CITY OF ALBUQUERQUE

November 6, 2017

**Re: Floor and Decor
4930 Pan America
Traffic Circulation Layout
Architect's Stamp 10-11-17 (F17D032)**

DRAWN BY:
XXX

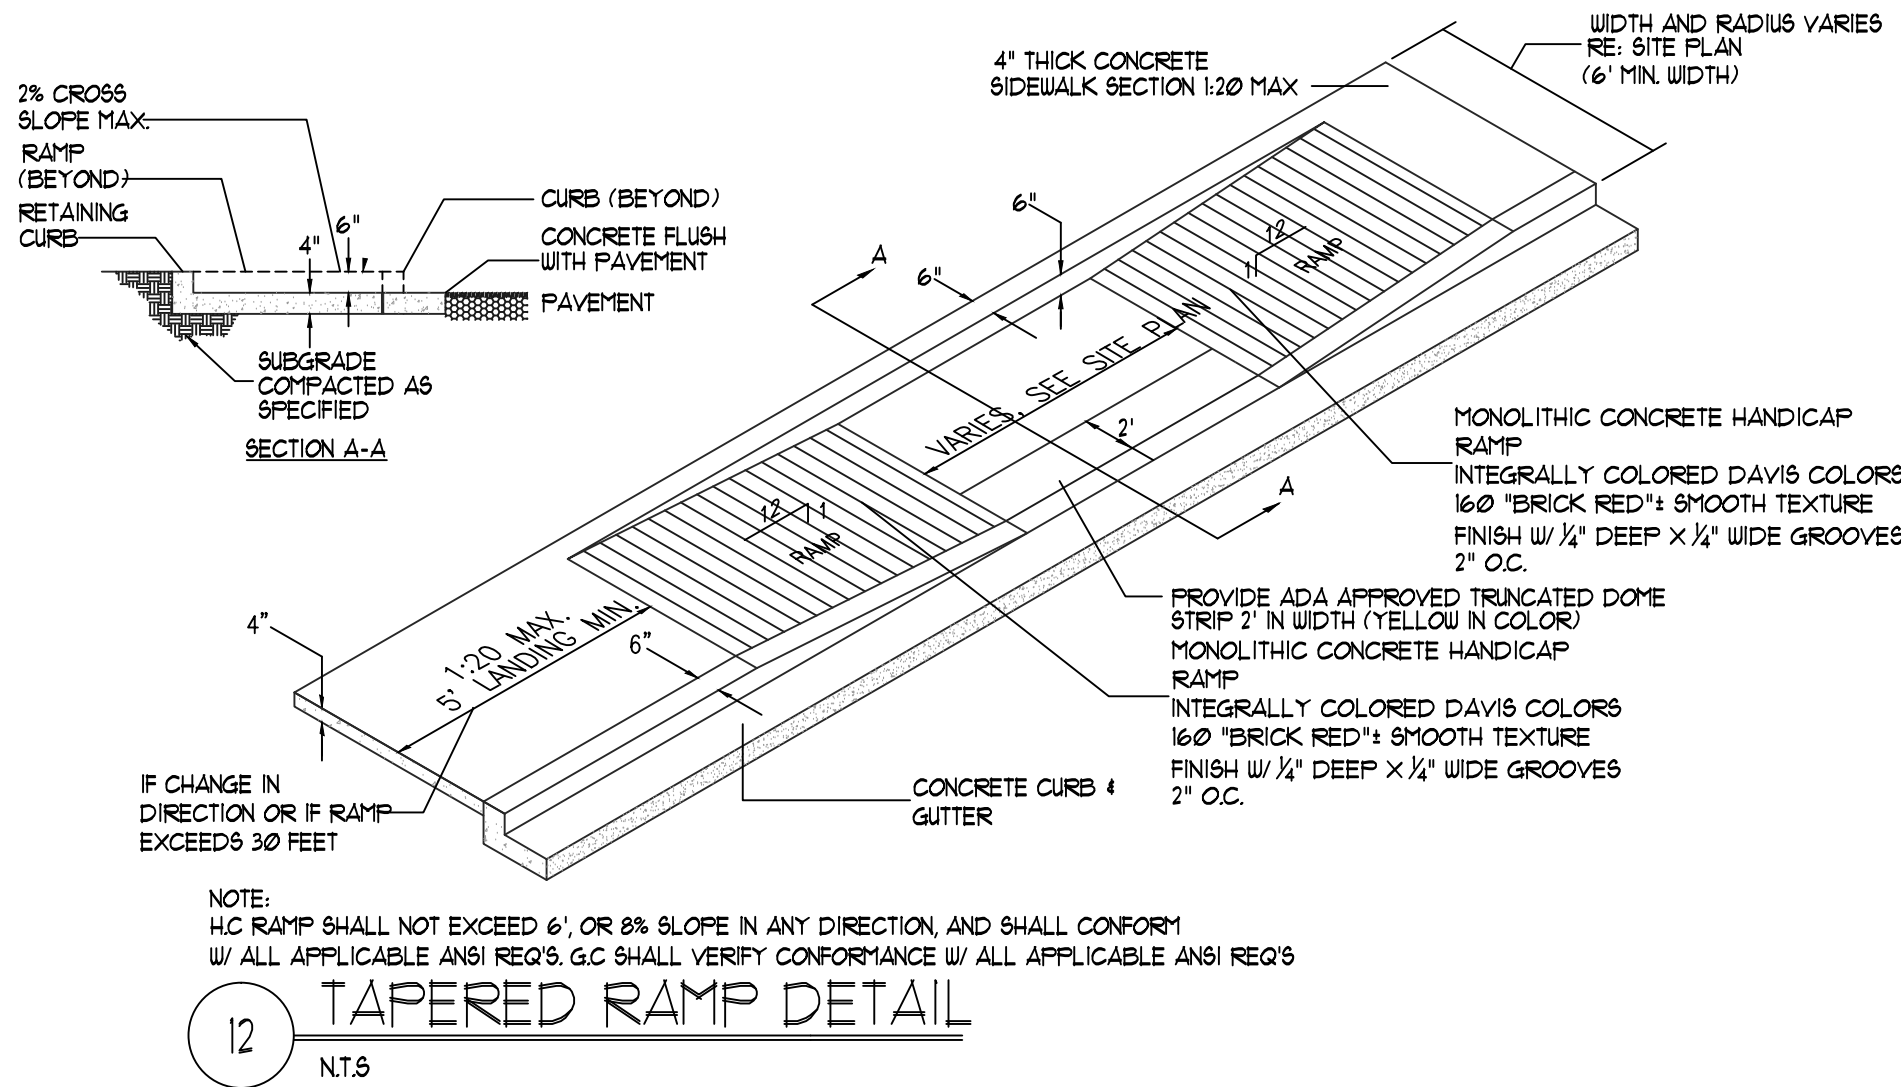
1. All sidewalks along streets should be placed at the property line.
2. Label the compact parking spaces by placing the words "**COMPACT**" on the pavement of each space.
